LAKE HAVASU CITY, ARIZONA

ADDENDUM NO. 1

**Mulberry WWTP Aeration Basin, Structural and MCC Upgrades
Project No.: PW-107018-500388**

July 19, 2023

**SS PLATE
INSTALLATION
DETAILS**

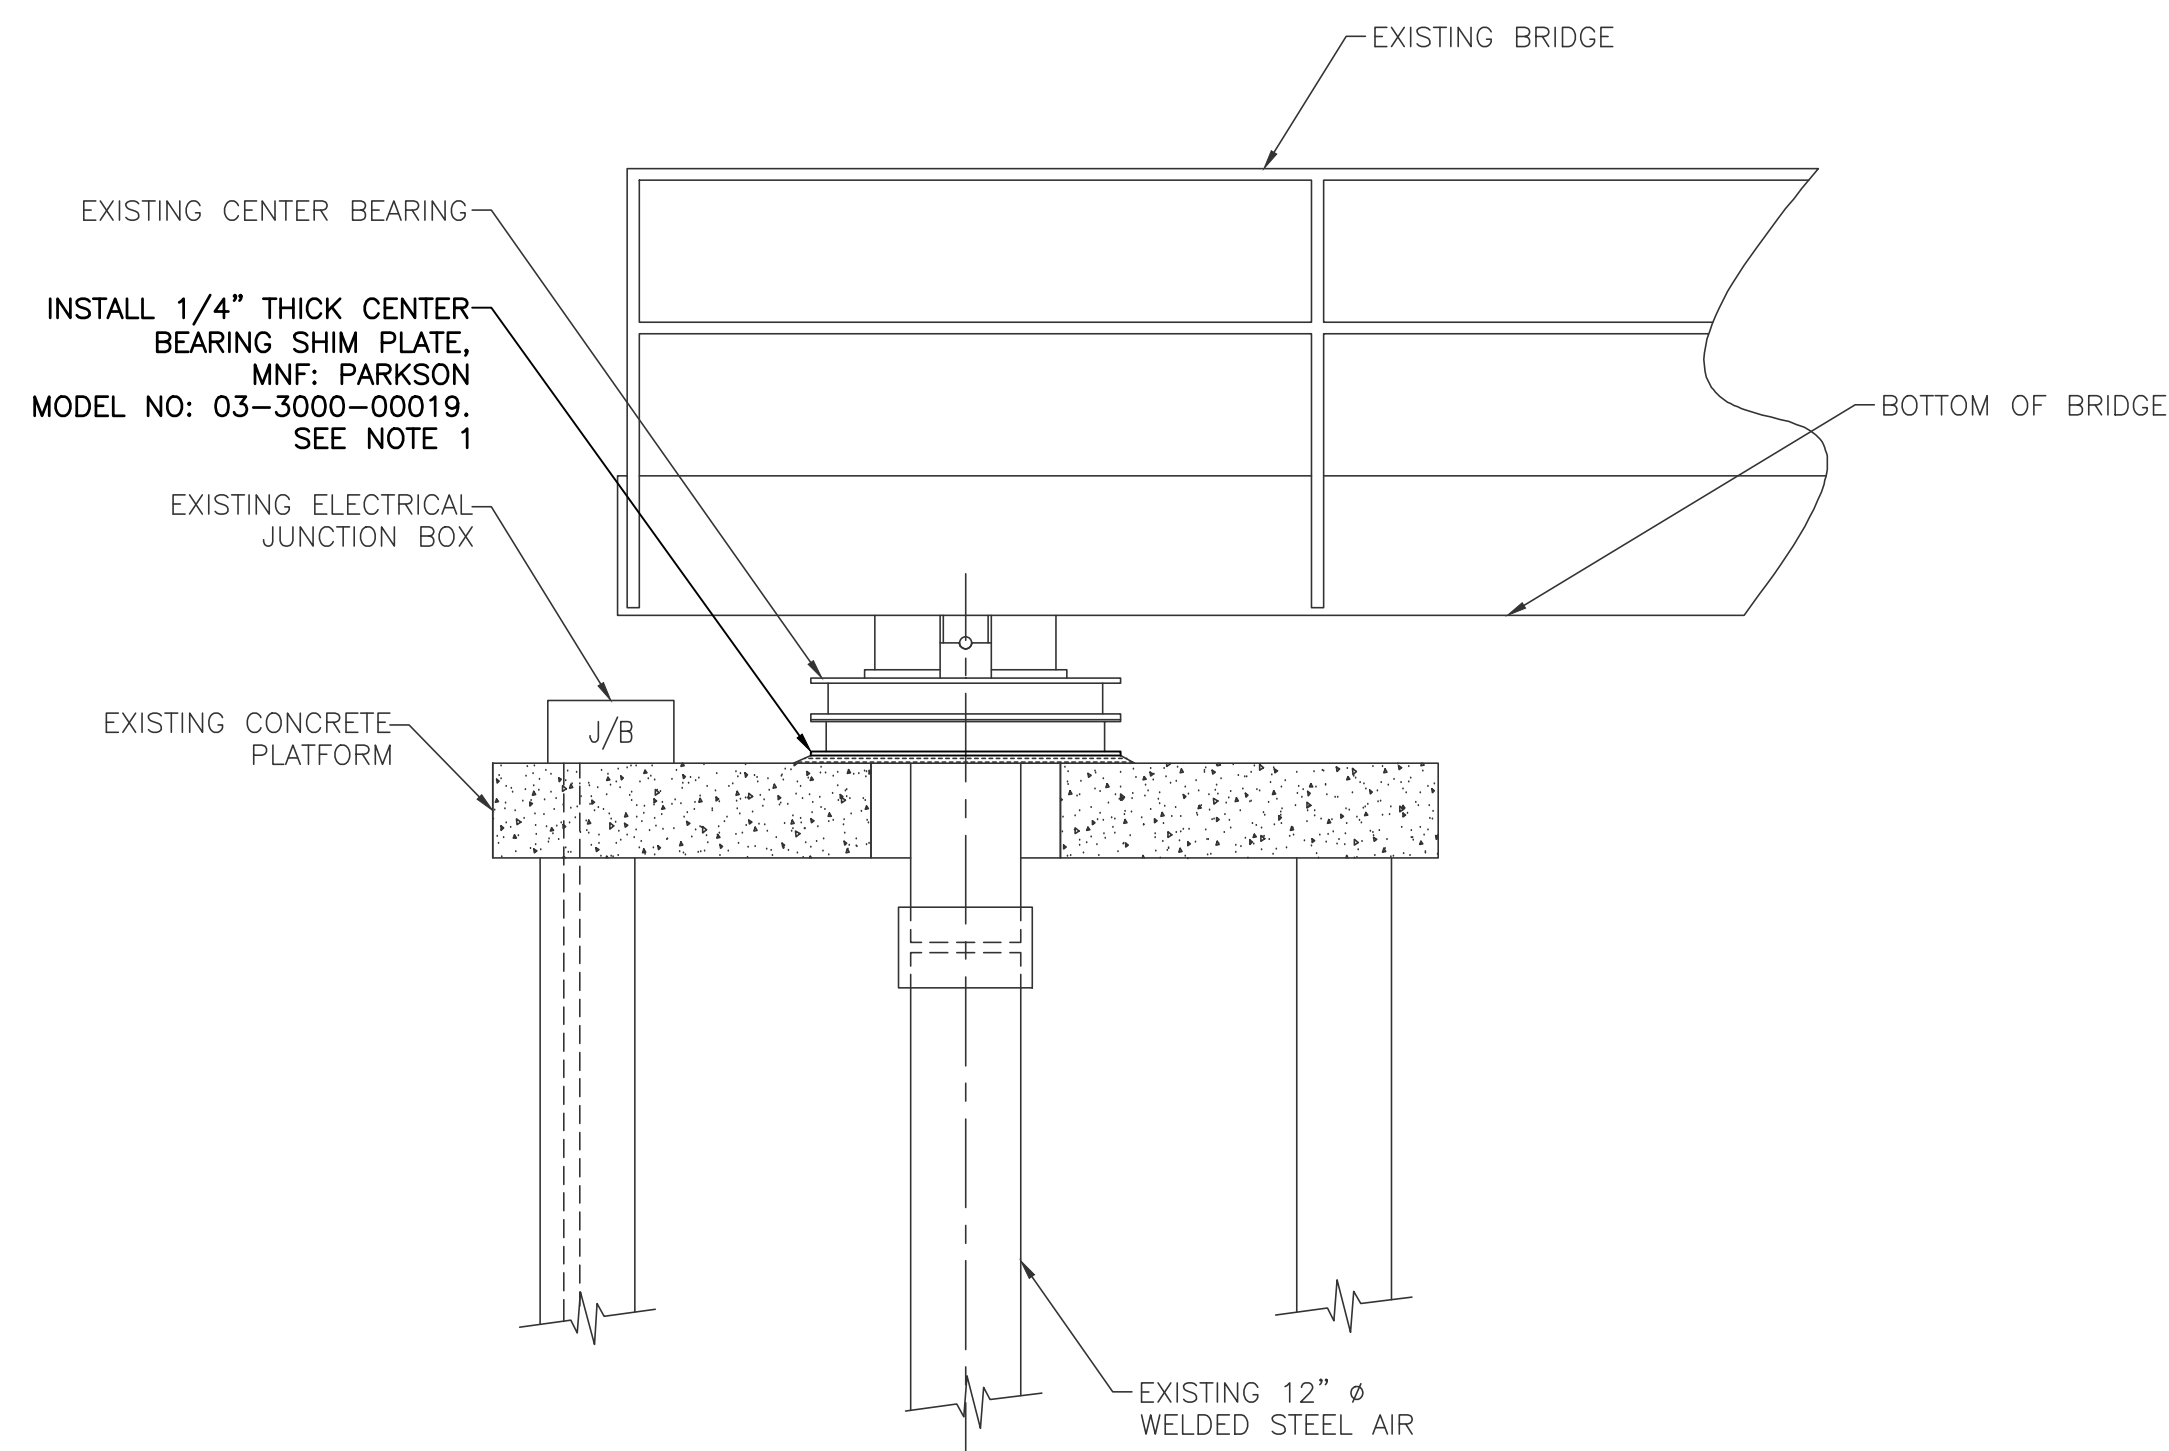
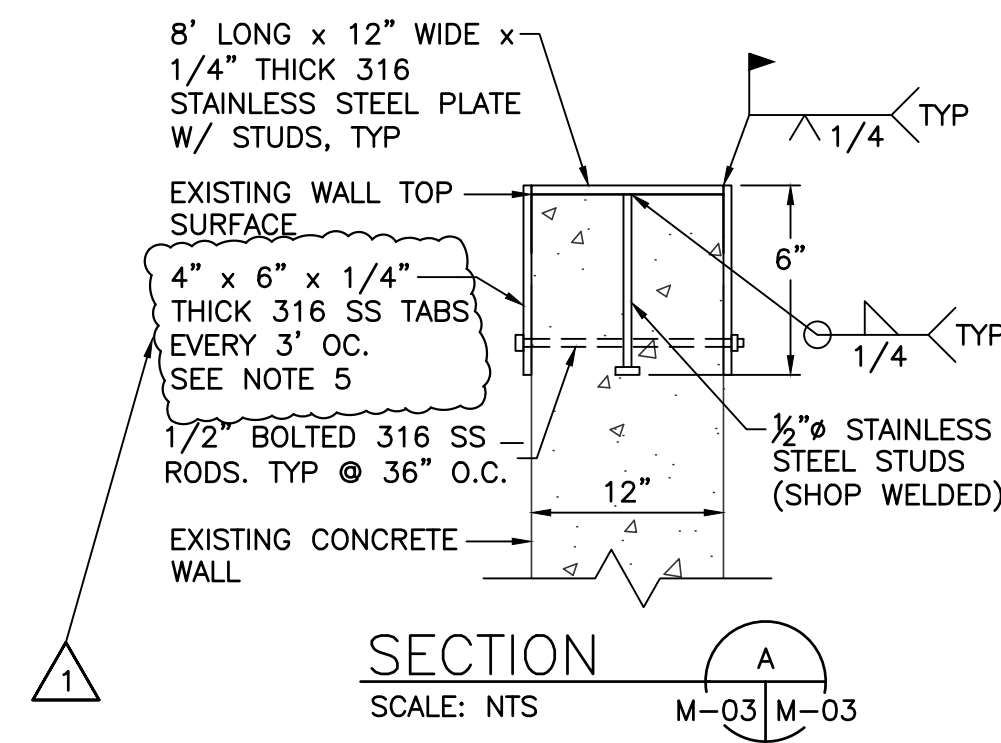
- NOTES:**
1. DRILL 5/8" x 7" LONG HOLES TO ACCOMMODATE THE 1/2" SS STUDS.
 2. PRIOR TO INSTALLING EPOXY, BRUSH CLEAN AND AIR BLOW HOLES TO REMOVE DUST OR LOOSE MATERIAL.
 3. DURING THE SS PLATES INSTALLATION, CONTRACTOR SHOULD REMOVE ANY EXCESSIVE EPOXY UNDERNEATH THE PLATES.
 4. ADJACENT PLATES SHOULD BE AT SAME LEVEL (ELEVATION).
 5. FOR THE AREAS WHERE THE BASINS' WALL EXTERIOR EXPOSED SURFACE DEPTH IS LESS THAN 8", PROVIDE 1/2" x 4" LONG STAINLESS STEEL CONCRETE WEDGE ANCHORS.

2. There seems to be a conflict on the actual overall dimension of each steel plate. On page M-03 we see a note that states they are 8' feet long but the plan view shown shows dimensions that equal on 7'. Which is it?

- A. The correct length of the plates is 8 ft. The steel plate installation detail on Sheet M-03 is now corrected. See Addendum No.1.
3. Sheet E-401; Is a metal building an option instead of precast?

- A. Yes, concrete wedge anchors installation is acceptable where the exposed face of the basin is less than 8" depth. See Addendum No.1
24. What will the effluent level be in each basin during construction, and will the aeration traveler be stationary?

PREFABRICATED EQUIPMENT BUILDING

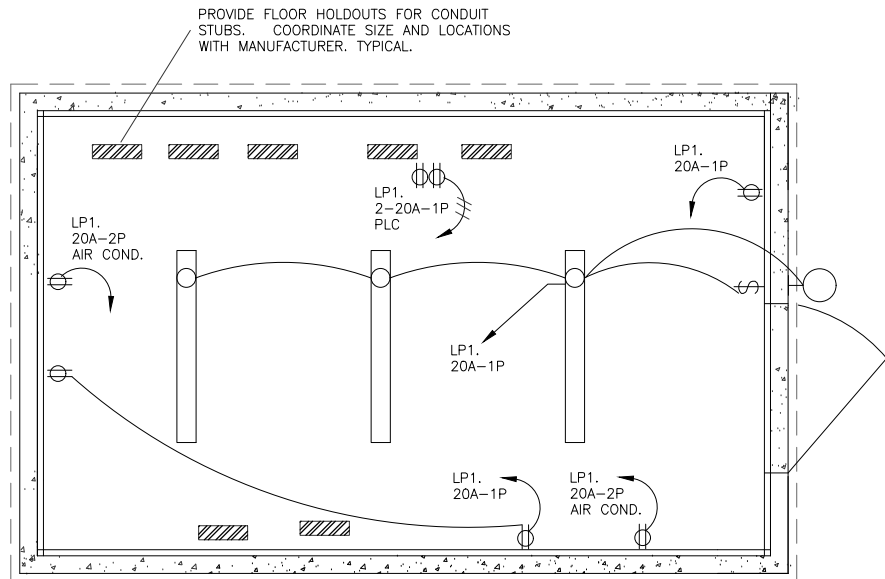
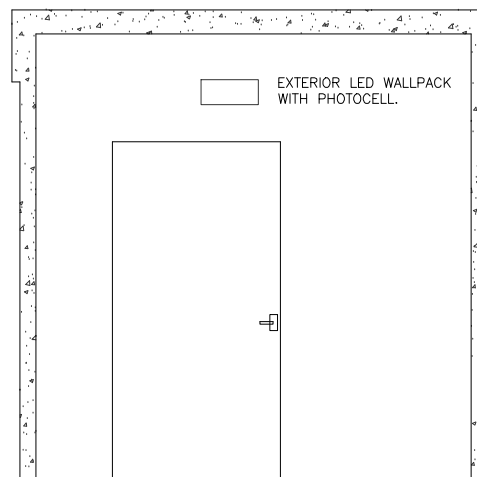
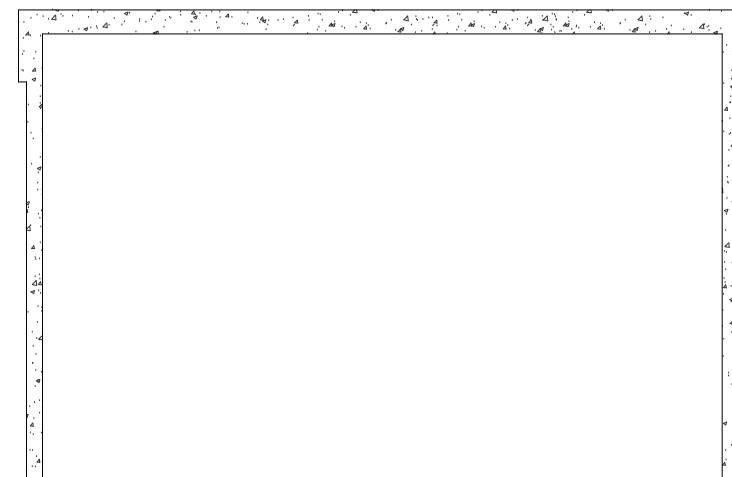
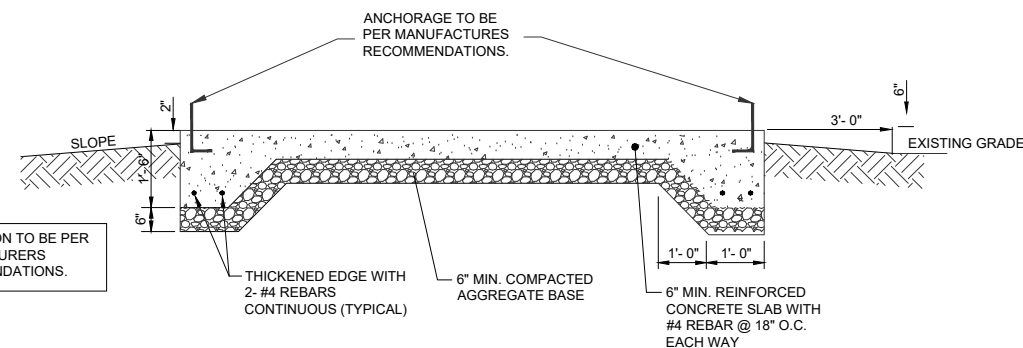
- A. No.
4. Sheet E-401; Is a masonry building an option instead of precast?
 - A. No.
5. Sheet E-401; Oldcastle Precast Model #1122 is not offered anymore.

- A. Modified the precast notes, see Addendum No.1.
6. Door is called out as 4' wide but no height given – 7' or do you need a 1' transom added?
 - A. Door height is now added to the Sheet E-401, see Addendum No.1.

8. Sheets E-302, E-401; Building layout show Panel B but on the one-line diagram is shown as Panel S. I think it was just a typo on the building layout & should be Panel S – please confirm.

SPECIFICATIONS:
 MINIMUM EXTERIOR DIMENSIONS = 10'-6" WIDE X 16'-6" LONG X 10'-1" HEIGHT.
 2" OVERHANG AT ALL WALLS.
 SLOPE ROOF FROM 10'-1" TO 10'-0" FOR RUNOFF.
 SINGLE ENTRY 3'-6" WIDE X 84" COMMERCIAL DOOR WITH LOUVER AND FILTER.
 DOOR HARDWARE TO INCLUDE COMMERCIAL GRADE PUSH-TO-EGRESS HANDLE, AND DEADBOLT LOCK WITH INTERNAL KNOB.

⚠️ PREFABRICATED METAL OR IN PLACE MASONRY BUILDINGS ARE NOT ACCEPTED SUBSTITUTIONS

- A. On Sheet E-401, “Panel B” is now renamed as “Panel S”. See Addendum No.1
9. Sheets C-02, M-01, M-02; On Sheet C-02 Site Plan it indicates and points to Aeration Basin No 2 as "AERATION BASIN REHABILITATION WORK UNDER THIS PROJECT". Yet on Sheets M-01 and M-02 you show both Basin No. 1 and number 2 requiring work. Will both basins require work to be performed as shown on M-01 and M-02?

EXISTING CONDITION PHOTOGRAPHS

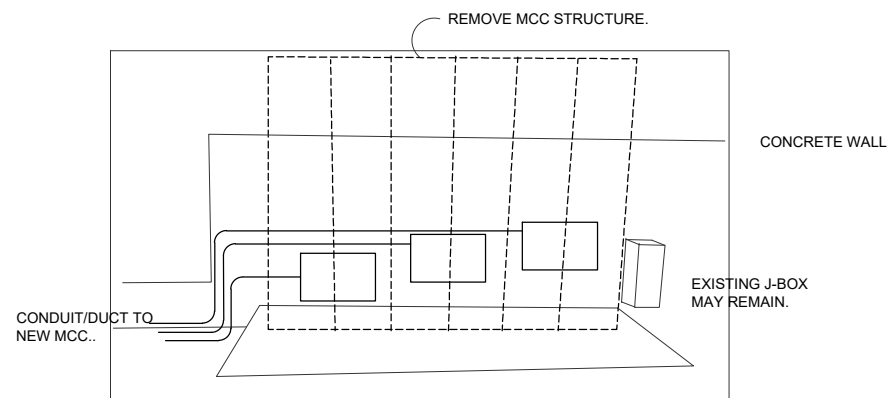
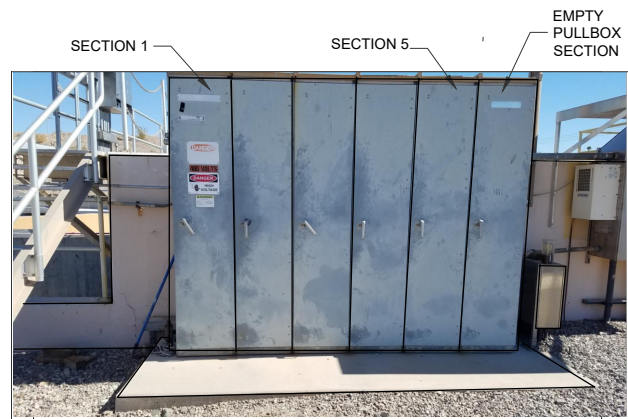
4. Delete Drawing Sheet M-03 in its entirety and replace it with the Drawing Sheet M-03 attached to this Addendum No.1.
5. Delete Drawing Sheet E-401 in its entirety and replace it with the Drawing Sheet E-401 attached to this Addendum No.1.
6. Delete Drawing Sheet E-501 in its entirety and replace it with the Drawing Sheet E-501 attached to this Addendum No.1.

EXISTING CIRCUITS TO FIELD PENETRATE THROUGH CONCRETE SLAB. PROVIDE JUNCTION BOX ENCLOSURES TO TRANSITION TO NEW CONDUITS TO NEW MCC.

INSTALL NEW J-BOXES TO TRANSITION TO THE EXISTING FIELD CONDUITS AND BRANCH CIRCUITS. LABEL ALL CONDUCTORS. UTILIZE TERMINATION BLOCKS FOR ALL SPLICES. WIRENUTS AND SPLIT BOLT CONNECTORS ARE NOT ALLOWED.

EXTEND CONDUIT PENETRATING FROM CONCRETE TO J-BOXES. PROVIDE PHYSICAL PROTECTION FOR THESE DUCTS. FABRICATE STAINLESS STEEL METAL COVERS FOR DUCTS. MOUNT TO CONCRETE.

THE EXISTING MCC ENCLOSURE IS PRESENTLY IN THE WAY THE J-BOXES. CONTRACTOR IS TO COORDINATE PHYSICAL REMOVAL OF MCC AND THE INSTALLATION OF THESE NEW J-BOXES. PROVIDE INTERIM TEMPORARY BRANCH CONDUCTORS FOR ANY AND ALL FIELD CIRCUITS UNTIL THE EXISTING MCC IS REMOVED. PROVIDE PHYSICAL PROTECTION OF THESE INTERIM TEMPORARY BRANCH CIRCUITS, SUCH AS PVC CONDUIT OR PVC COATED FLEXIBLE STEEL CONDUIT. CIRCUITS MAY BE COMBINED IN THE INTERIM DUCTS.
